MONTGOMERY COUNTY HISTORIC PRESERVATION COMMISSION
STAFF REPORT

Address:	7835 River Road, Bethesda	Meeting Date:	11/13/2024
Resource:	Master Plan Site #29/40 Magruder's Blacksmith Shop	Report Date:	11/6/2024
Applicant:	7835 River Road LLC (Constantine Stefanou, Agent)	Public Notice:	10/28/2024
Review:	HAWP	Tax Credit:	Yes
Permit No.:	1092363	Staff:	Laura DiPasquale
Proposal:	Fenestration alteration.

Figure 2: Proposed front door (left), plan (center) and existing door (right).

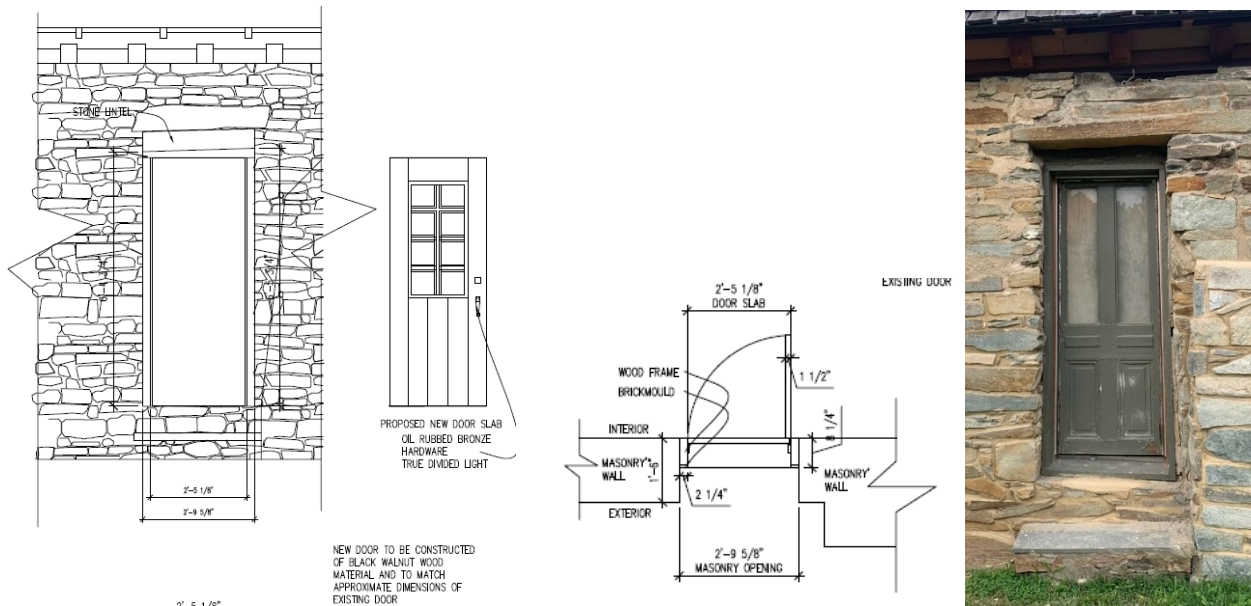
The existing front door has wood panels at the bottom and rectangular Plexiglass lites at the top. Previously, the applicant proposed to replace with a composite door with glass lites similar in design to the existing door. The applicant also proposes to replace the existing six-panel wood rear door. The applicant previously proposed a six-pane composite/fiberglass door at the rear. This application proposes new black walnut wood door slabs with dimensions to match approximate dimensions of existing and new oil rubbed bronze hardware and true divided lights. The doors would be recessed approximately 10 inches from the façade. The plan drawings show a flat brickmould, but do not specify its material. Staff finds the proposed doors in keeping with the HPC recommendations at the August 14, 2024 preliminary consultation review. Staff recommends that the brickmould be painted wood.

1. The applicant must provide a drawing or specification showing the true-divided-light detail with 7/8" to 1 1/8" putty slope muntins.
2. The brickmolds for all windows and doors must be painted wood.

Figure 4: The drawing for the 6/6 window on the front elevation and an existing photo.

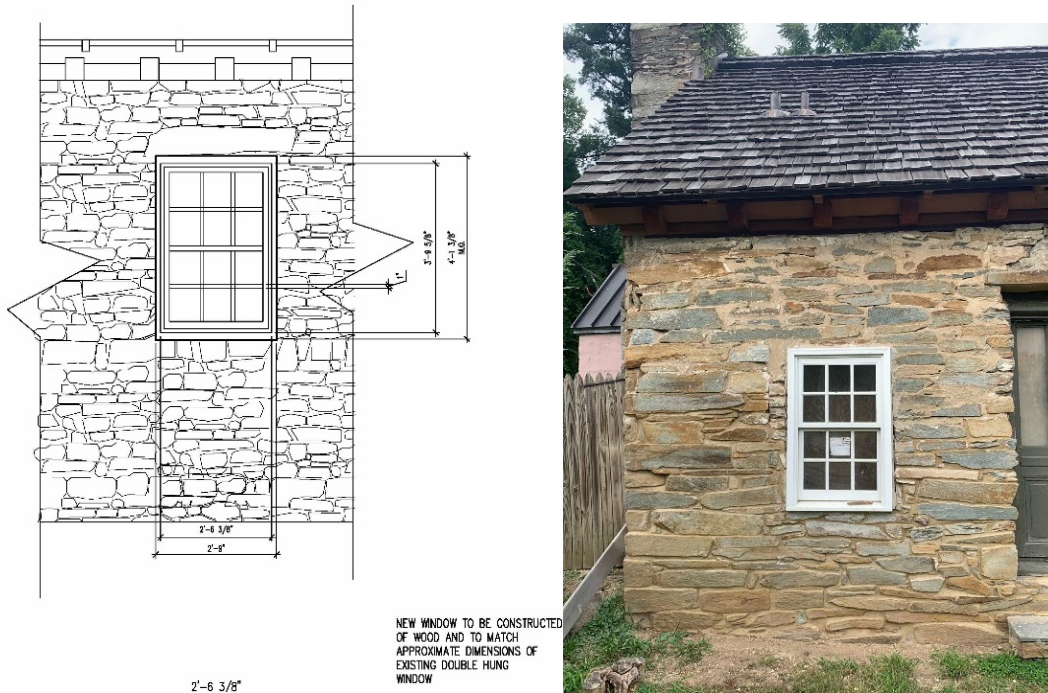
Staff supports the proposed replacement of the two 6/6 wood sash windows and six-lite wood hopper window and finds them compatible to the character of the building. The existing windows appear to be modern replacements, and the proposed appear to closely match the designs of the existing. Staff notes that the drawings do not include muntin details, and suggests that the windows have 7/8” to 1 1/8” putty slope muntins, and that the applicant provide details to staff for final approval.
